DECLARATION STATEMENT - RECORD OF DECISION

Syracuse China Inactive Hazardous Waste Site Town of Salina, Onondaga County, New York Site No. 7-34-053

**Syracuse China Site
Proposed Remedial Action Plan
Town of Salina (T), Onondaga County
Site No. 7-34-053**

SYRACUSE CHINA LANDFILL
CAPPING AND CONSOLIDATION
 DIVISION OF HAZARDOUS WASTE REMEDIATION
 DRAWING: DRAWN FROM GERAGHTY AND MILLER INC. BASE MAP
 REVISION: 3/15/96
 DATE: 3/15/96
 MODIFIED BY: STEVEN M. SCHARF, P.E.
 NYSDEC SITE ID No. 7-34-53
 FIGURE 4

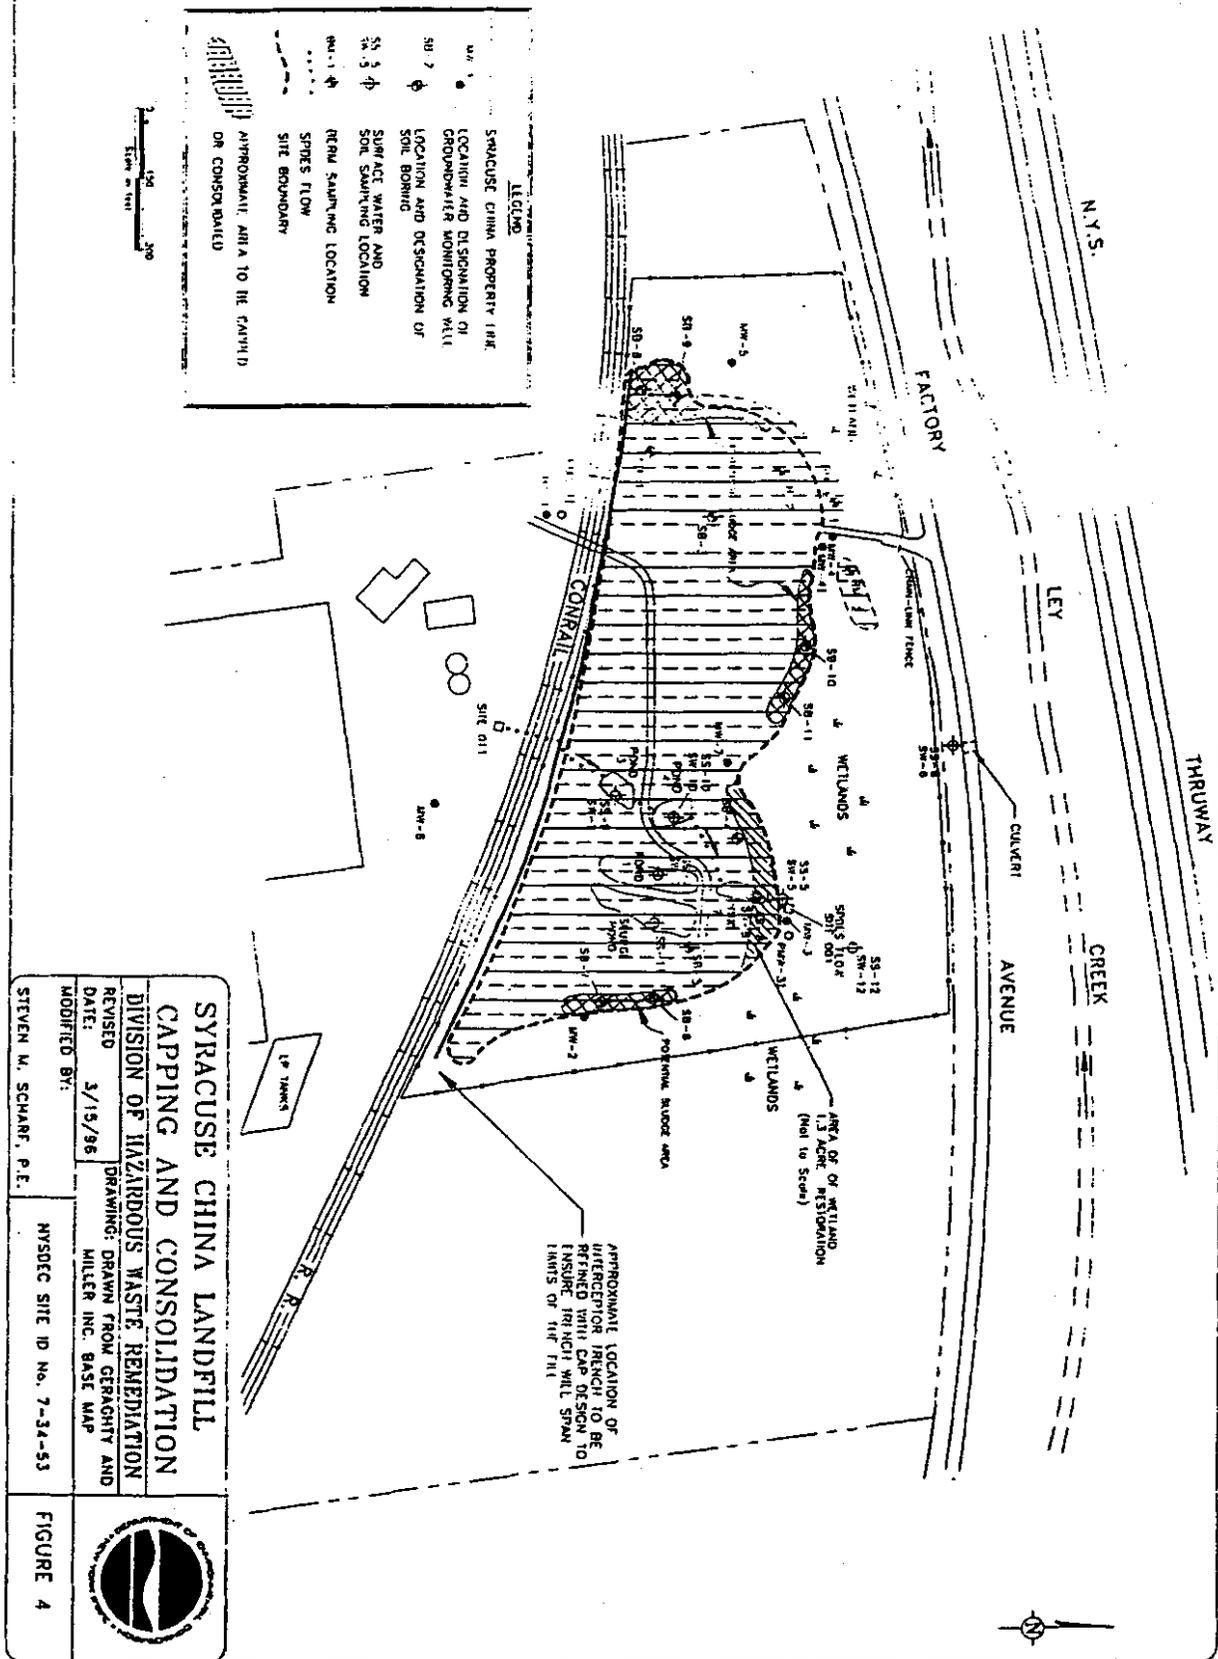
COMMENT 31: The preferred remedy provides for the installation of an interceptor trench "...designed to intercept groundwater passing through the fill and lower the water table below the fill, to prevent leaching of lead into the groundwater." (PRAP at 17). Based on the information submitted with the RI/FS, the extent that groundwater is in contact with the fill material, if any, has not been determined adequately. Although the cross-section drawings in the RI depict the base of the fill material in contact with the top of the water table, in some locations (RI, Figure 4) this depiction is based on available, but limited, data. These limited data have been interpolated to provide a presentation of hydrogeologic conditions at the landfill and do not reflect precise groundwater conditions at all locations in the landfill. In fact, soil borings and test pits excavated through the base of the fill material in several locations did not indicate the presence of groundwater in contact with the fill material. Additional data should be collected as part of the pre-design phase of the remediation to further define whether the fill material is in contact with the groundwater. Until this information is developed, it is premature to recommend that there is a need for the proposed groundwater interceptor trench as part of the preferred remedy.

RESPONSE 31: The Groundwater Interceptor Trench as included in the proposed remedy in the PRAP is the same as that proposed by the PRP in their feasibility study. While the NYSDEC agrees that the available data is somewhat limited, the presence of some portion of the landfill below the groundwater table is well established. Since other technologies or strategies exist for achieving the end result of the interceptor trench, such as relocation of the fill in areas below the groundwater table or collection of any leachate generated, the ROD has been modified to allow a further evaluation of data to best determine the means of achieving the required prohibition of the leaching of lead from the landfill into the groundwater. As proposed, the interceptor trench is still significantly less costly than other means of addressing the leaching of contaminants to the groundwater such as the solidification/stabilization treatment evaluated in alternatives 4 A/B and 6A/B.
